From: Amber Cannon [ACannon@yatespetroleum.com]
Sent: Wednesday, May 23, 2012 4:26 PM
To: Bratcher, Mike, EMNRD
Subject: 5/23/2012 Meeting

I just wanted to send a quick summary of our conversation this afternoon about the Cigarillo SWD #1 and the Achen Frey DM Battery.

Achen Frey DM

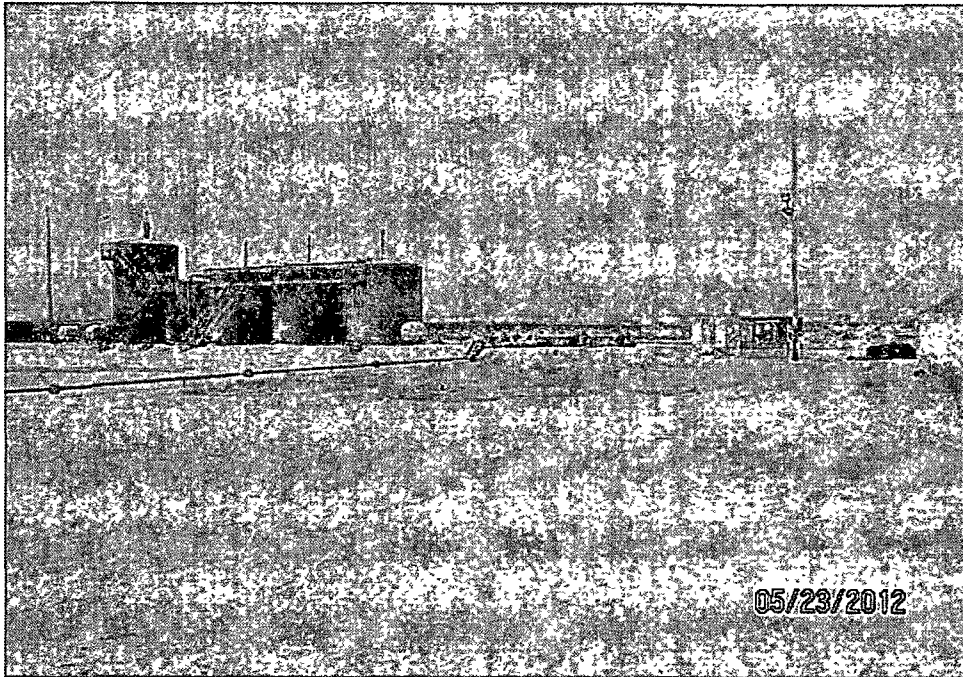
When I originally sampled this release, I divided it into four different sections. After sample results came back, the two sections of concern are one (1) and four (4). Section one (1) has been excavated through 5' due to TPH/BTEX levels over the RRAL's. Further samples were taken at 6', 7' and 8'. Samples at 6' and 7' came back within limits, however, the 8' sample showed a significant increase in TPH/BTEX levels. Yates returned to this location this afternoon and obtained samples at 9' and 10'. We feel that the 8' sample could have been cross contaminated and will have a better idea of this assumption once the results for 9' and 10' come back. Samples will be sent to the laboratory tomorrow. When we have results we will be able to determine if more soils need to be excavated.

You were concerned with the chloride levels of section four (4) at 5' and requested that Yates take a 6' sample to see if there is more decrease in these levels. Yates returned to the site this afternoon and we were able to obtain this requested 6' sample. Sample will be sent to the laboratory tomorrow.
